Aluminum Rack Panels *PBPA Series*

We are making changes to the design of this product.

Old Design (Left) | New Design (Right)

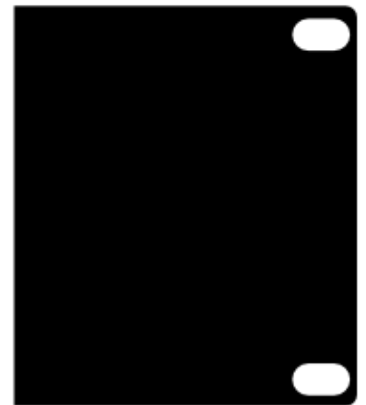
We are enclosing the rack mounting holes and rounding all edges.
